Sheringham Shoal and Dudgeon Offshore Wind Farm Extension Projects

Addendum to the Flood Risk Assessment

Revision A

Document Reference: 14.31

Figure 1: 1 in 100 year plus 45% for climate change with OnSS platform level set at 28.23m AOD and NW access road

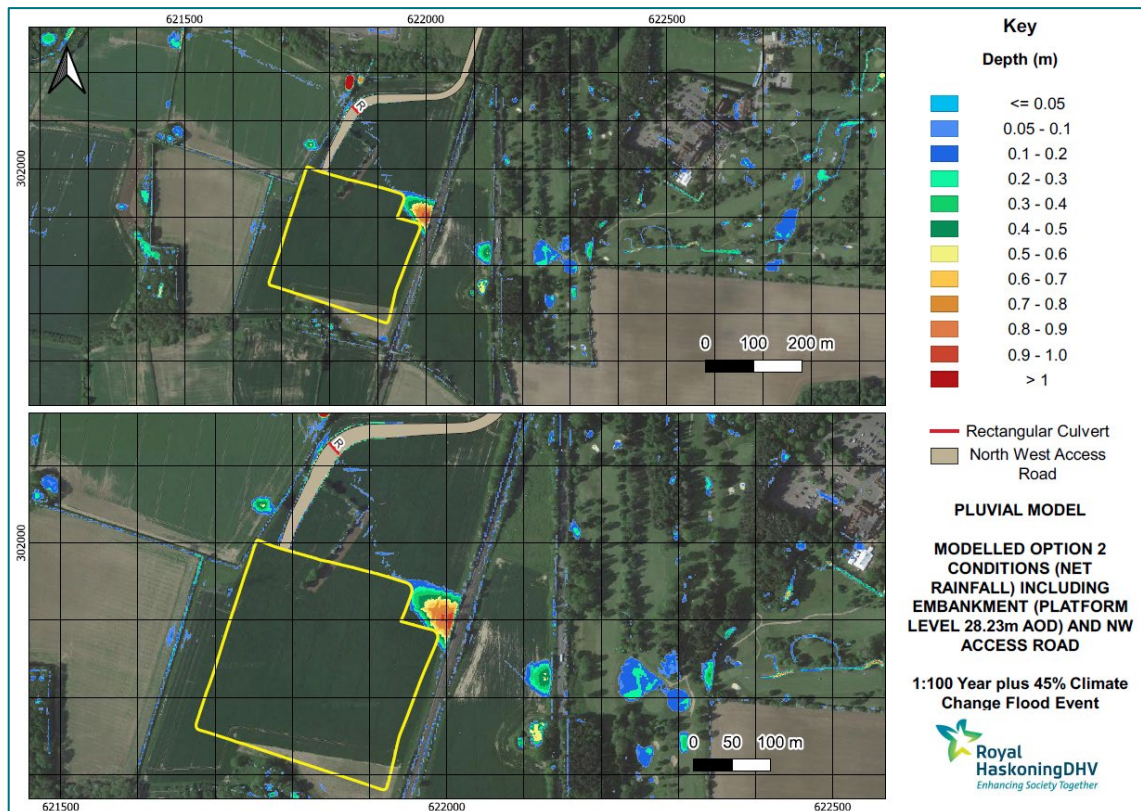
61. Comments were provided by the LLFA in their **Relevant Representation** [RR-064] with specific regard to the requirement for an update to the surface water hydraulic model for the Onshore Substation such that it applies the latest climate change allowances and provides an assessment of the change in flood risk.

65. Figure 9-23 of the **Annex 18.2.2: Onshore Substation Hydraulic Modelling Report (Revision B)** [document reference 6.3.18.2.2] is reproduced below as **Figure 1**. The results from this modelling scenario demonstrate there is minimal interaction between the Onshore Substation platform and North West (NW) access road and the surface water flood extent during the 1 in 100 year plus 45% climate change allowance event.

66. The results also confirm that whilst the flood depth adjacent to the Onshore Substation platform varies, it is not of a sufficient depth to result in flooding to the Onshore Substation platform. In addition, it confirms that the NW access road can be designed such that there is continued conveyance beneath it.

67. On this basis neither the Onshore Substation platform nor the NW access road will result in flooding to SEP and DEP. Furthermore, they will not result in displacement of surface water flooding such that there would be an off-site impact on surface water flood risk.
